# CHAPTER 2 DESIGN REFINEMENTS

## 2.1 INTRODUCTION

## 2.2 SUMMARY OF DESIGN REFINEMENTS

Figure 2-1: Revised Milpitas Station Plan

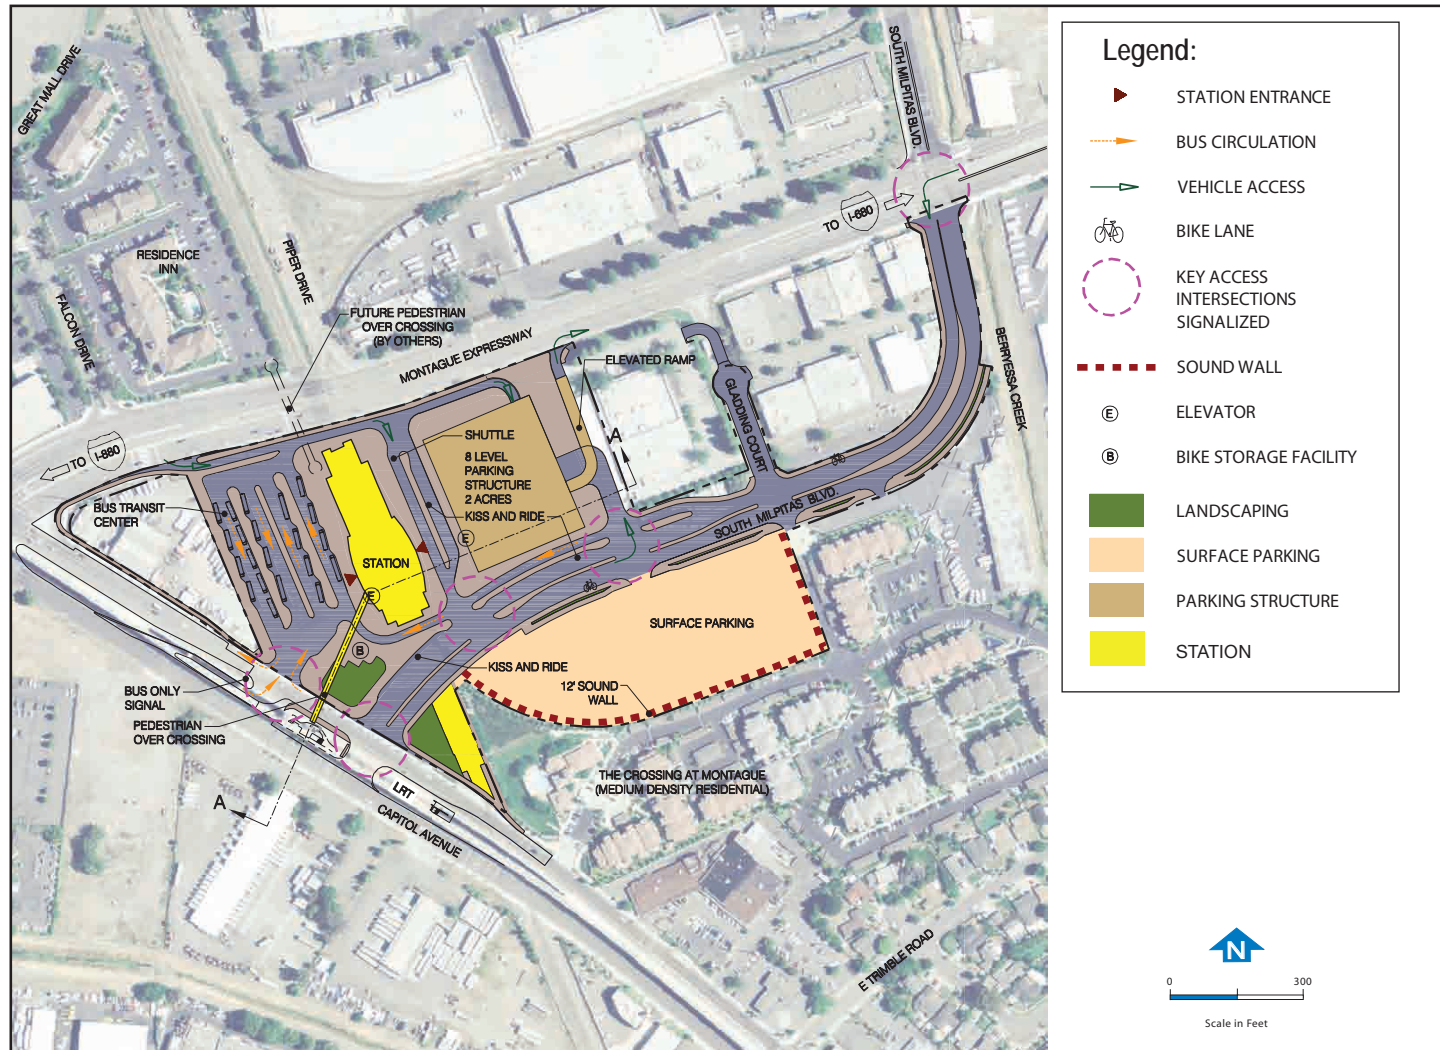
- **Design Refinement 5 – Draft SEIR -2 Design Change 15 – Milpitas Station.** The Milpitas Station footprint has been reduced from 27 acres to 20 acres by eliminating the surface parking and/or future transit facilities in the northeastern (between South Milpitas Boulevard and Montague Expressway) and northwestern (at the intersection of Montague Expressway and Capitol Avenue) portions of the station site plan. **Figure 2-1** shows the revised Milpitas Station site plan. This refinement is shown on Figures B-16C, B-17, and B-18 of **Appendix B** to this Final SEIR-2.

The Milpitas Station footprint has been reduced by eliminating the surface parking and/or future transit facilities in the northeastern and northwestern portions of the station site plan. The station footprint is now 20 acres.

**The Milpitas Station footprint has been reduced from 27 acres to 20 acres. Modification of the station footprint reduced the number of displacements from 20 businesses (under the approved project in the FEIR and SEIR-1) to 15 businesses. VTA will provide financial assistance and relocation services to owners and occupants of businesses displaced by Phase 1 as part of VTA's Relocation Assistance Program. VTA's Relocation Program is consistent with all federal and State laws applicable to business and residential relocations. Therefore, impacts would be less than significant and no further mitigation would be required.**

Figure 2-2: Revised Berryessa Station Plan

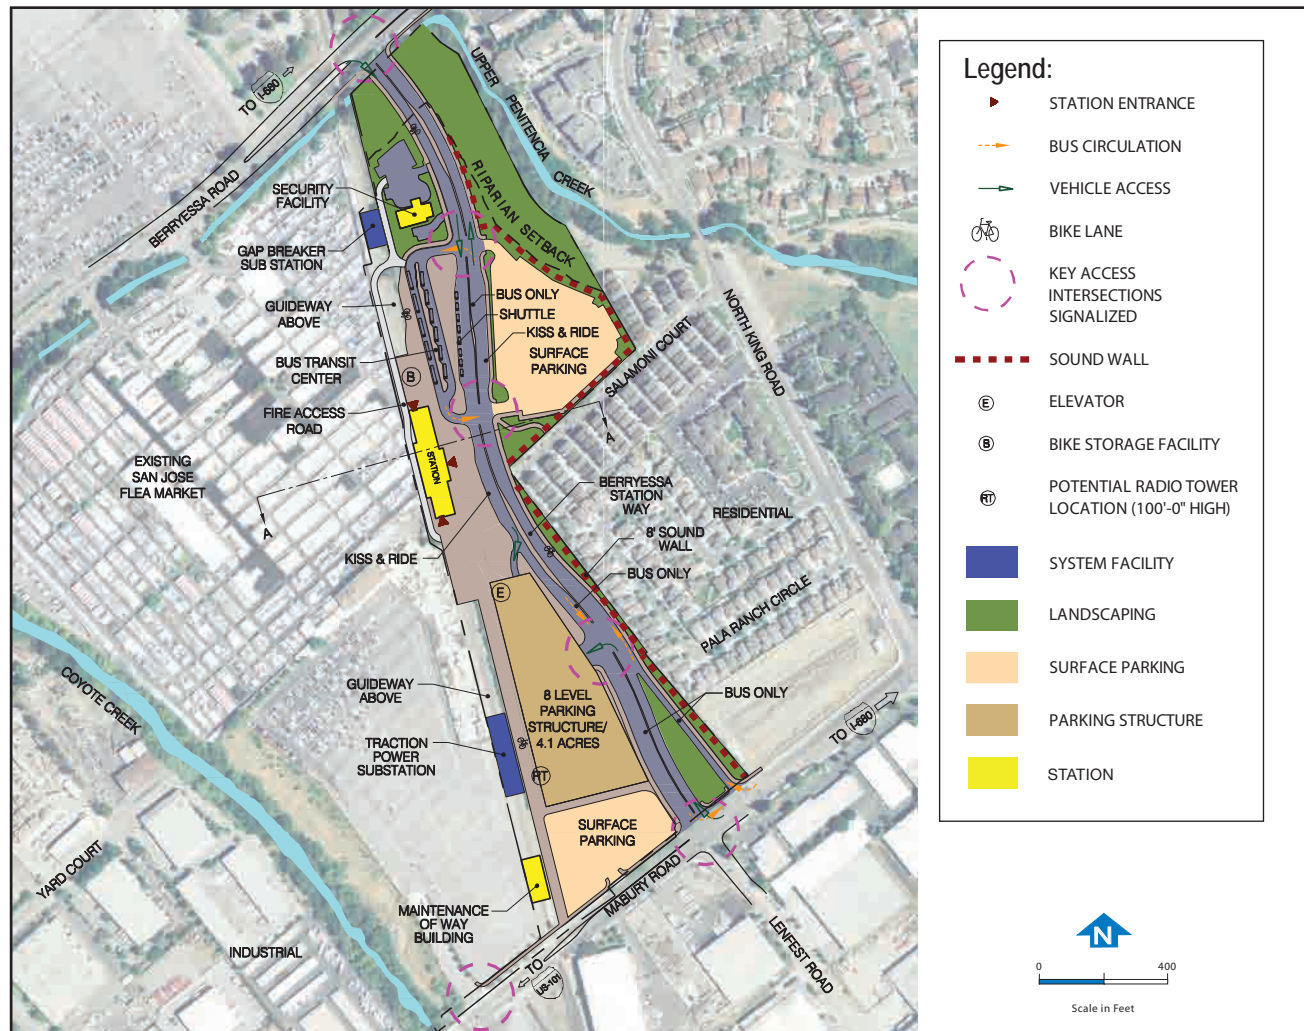
- **Design Refinement 7 – Draft SEIR-2 Design Change 20 – Berryessa Station.** The Berryessa Station footprint has been reduced from 55 acres to 30 acres by eliminating the surface parking and/or future transit facilities on the west side of the UPRR track/proposed BART alignment immediately adjacent to Coyote Creek. **Figure 2-2** shows the revised Berryessa Station site plan. This refinement is shown on Figure B-23 of **Appendix B** to this Final SEIR-2.

The design of the parking facilities has been modified to include an eight-level parking structure on 4.3 acres on the southern half of the site and to the east of the UPRR ROW. ~~Additional surface parking and/or future transit facilities would be located as needed within the station area.~~

Figure 2-6: Montague Expressway Construction Staging Area

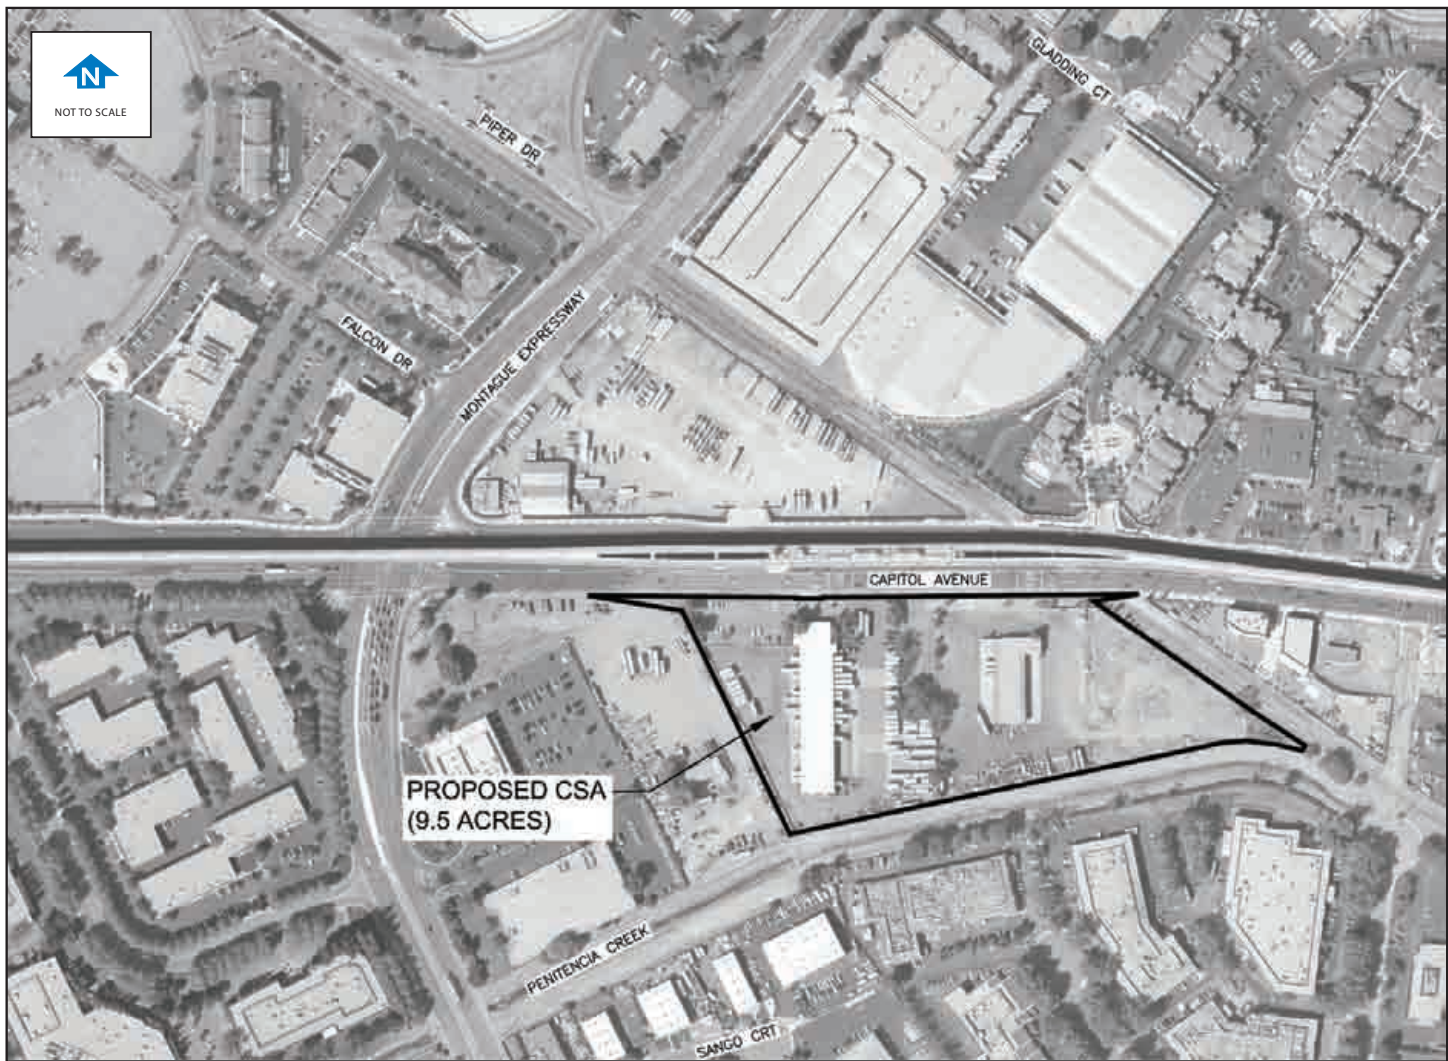
- **Design Refinement 8 – Draft SEIR-2 Design Change 23 – Construction Staging Areas.** A new 1.7-acre construction staging area has been established within the former Milpitas Station footprint near the intersection of Montague Expressway and Capitol Avenue. This new Construction Staging Area (CSA) is referred to as the Montague Expressway CSA. **Figure 2-6** of this Final SEIR-2 shows the Montague Expressway CSA. All CSAs relevant to Phase 1 are shown in **Figures 2-3** through **2-10** of this Final SEIR-2.

The Montague Expressway CSA would be added as part of this design refinement. No other changes to the CSAs would occur.

A new **Figure 4.19-5** has been added to the Draft SEIR-2 to show the Montague Expressway CSA. A figure showing the Capitol Expressway CSA has also been added; this figure was incorrectly omitted from the Draft SEIR-2.<sup>5</sup> The ordering of **Figures 4.19-2** through **4.19-9** has also been revised to correct an error in the Draft SEIR-2. The revised figure numbering sequence is as follows:
